Section 3.2 Water Resources

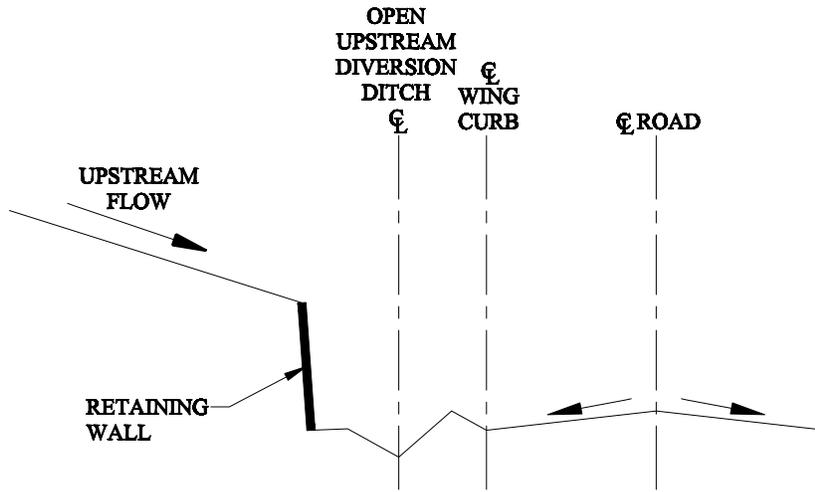
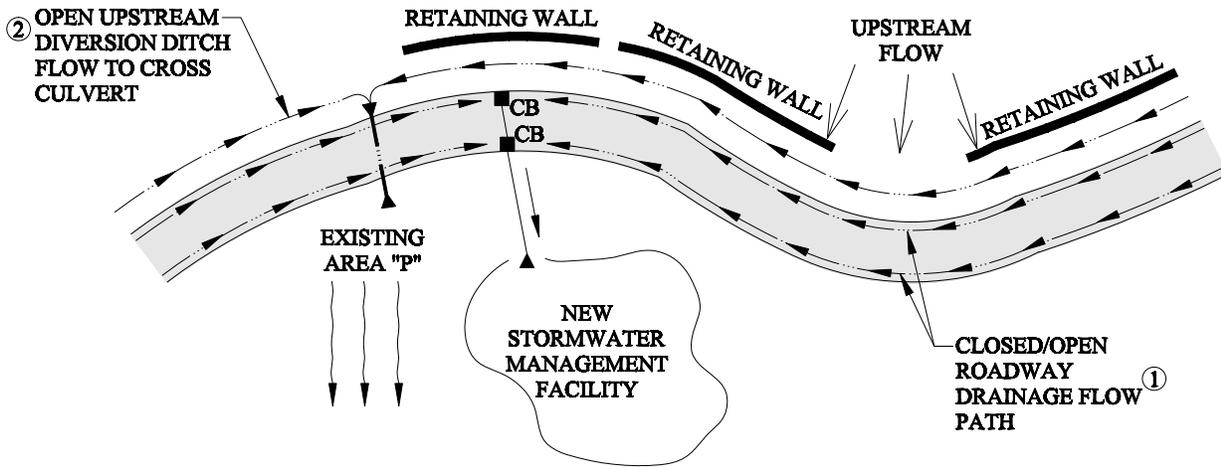
Comment 3.2-4-33Y: Wetland P is identified on DEIS wetland map, but there is no discussion of it. It is not an isolated wetland because it has a connection to wetland "L". Wetland P appears to be a spring that supplies a small stream identified as wetland "M". Wetland P needs to be discussed in the DEIS because it is nearly surrounded by Block J single-family residences that are perched on the steep slopes within a few feet of the wetland. A road is proposed on the western side several feet above wetland P. These residences and the road should be evaluated as possible threats to this spring fed wetland. When the wetland was visited by members of the Planning Board in February 2007, there was water flowing from the spring and Dr. Klemens commented to the effect that it would be salamander habitat. The grading plan indicates that a great deal of construction will go on around wetland P including major alterations of already steep slopes surrounding the wetland. This should be discussed in the DEIS even though the wetland is a small one. The maps on the following pages shown the location of wetland P. [David Reagon, Letter, March 20, 2008, Comment Y, pages 19-20]

Response 3.2-4-33Y: Area P is identified within the DEIS as a stream that originates from the adjacent hillside as a seep. It is described in the DEIS in Table 3.2-1, "Stream Characteristics," as an intermittent NYSDEC Class C stream, approximately 2 to 4 feet wide with 0.5 to 3 foot banks and a silt/cobble bed. To minimize impacts to this stream corridor, the roadway and surrounding buildings are separated from the headwall of the stream by a 50 foot set-back area. In order to ensure that adverse impacts from development are minimized, hillside flows from natural areas are designed to be segregated from stormwater runoff from developed areas. Runoff from developed areas, such as the residences, the surrounding lawns, and paved surfaces such as the driveways and roadway will be collected and conveyed into the stormwater treatment system. Flows from natural areas will be directed into a grassed diversion swale located adjacent to the roadway and will be collected and discharged into the headwall of Area P. In this way, both the quantity and quality of flow into Area P will not be impacted by the development. Figure 3.2-1 provides a schematic detail of how the natural area flow path will be segregated from the roadside and developed areas drainage path.

Figure 3.2-2

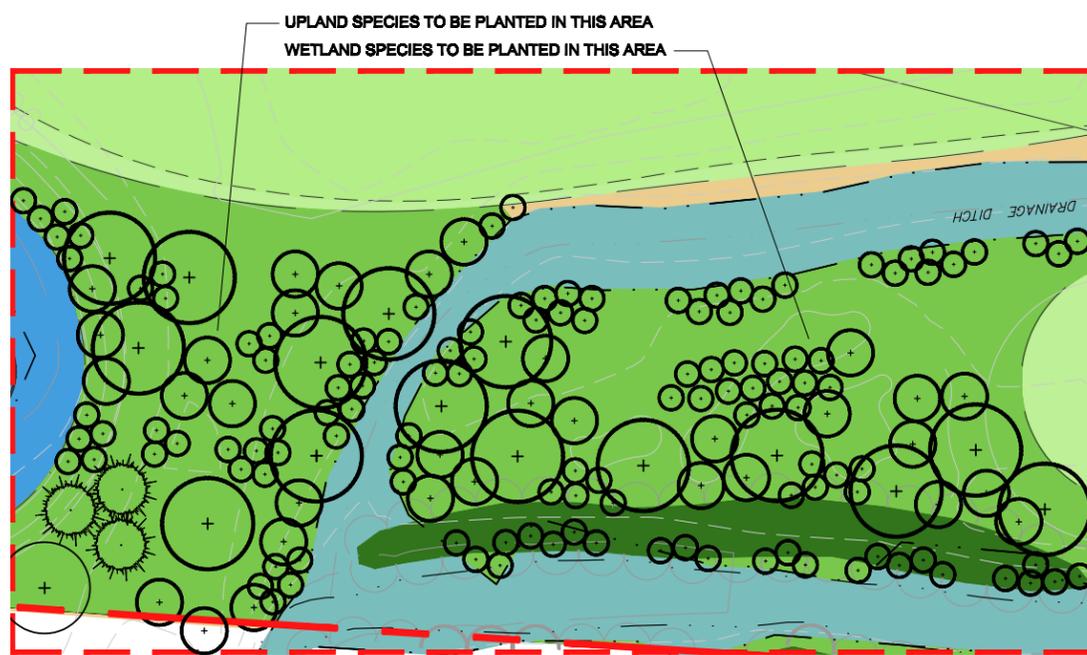
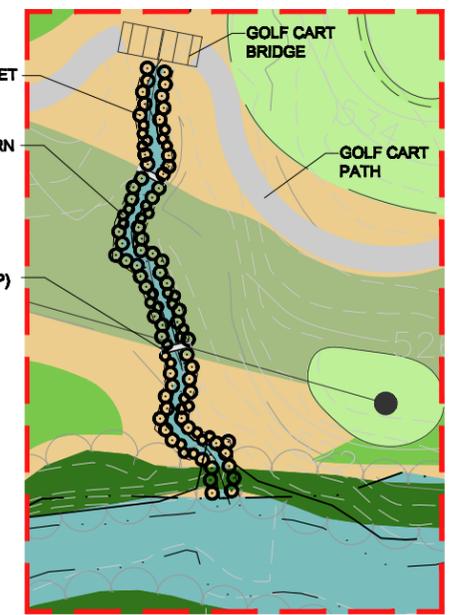
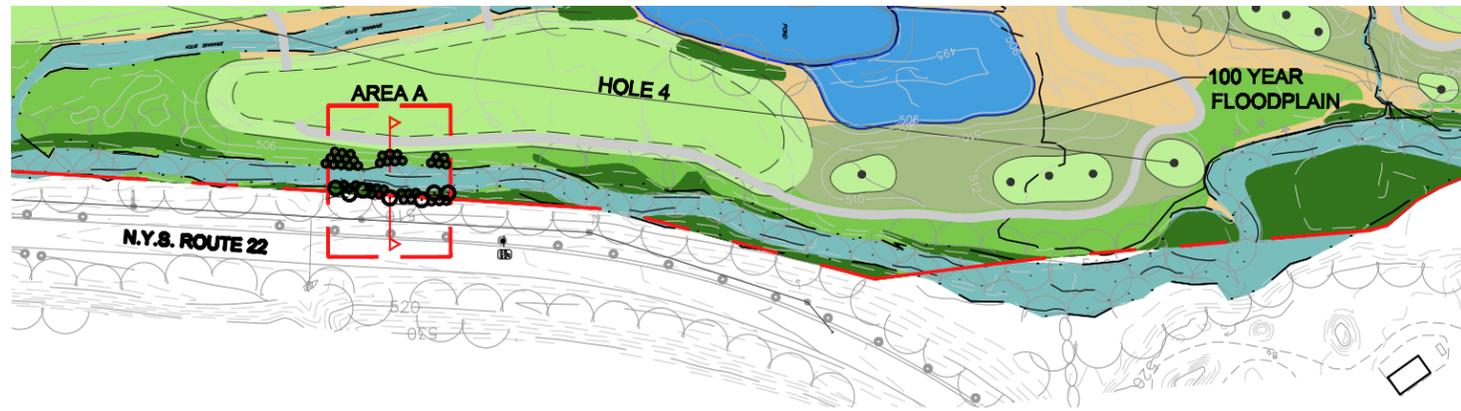
Comment 3.2-22-GP37: Figure 3.2-1 does not show 100 year floodplains. Furthermore, the DEIS states there will be some grading within the floodplain for redevelopment of the 4th fairway for the preferred alternative. The specific details of the grading needs to be described and potential impacts identified for evaluation in the FEIS. Will the grading be reshaping the land? It also appears that enhancement to Pond A, Pond B and Pond D will also occur within the floodplain area. Potential impacts related to these activities will need to be identified. The applicant needs to explain how this is consistent or inconsistent with the purposes of the RDO as it relates to significant protection of water resources. [Greenplan, Inc., Letter, April 6, 2008, Comment #37, pages 6-7]

Response 3.2-22-GP37: The approximately 6 acres of grading within the 4th Fairway is for reshaping the existing golf course use in support of a minor golf course modification. The net cut and fill within the floodplain area is balanced (i.e., essentially zero) and thus will not change the associated floodplain elevation. In addition, consistent with NYSDEC discussions, the reshaping of the land within the 4th fairway will involve enhanced plantings and buffer immediately adjacent to the Amenia/Cascade Brook. See Response 3.2-5-34A. Modifications to the ponds referenced were discussed in other DEIS sections. Figures 3.2-2 and 3.2-3 show floodplain restoration and planting around Hole 4.
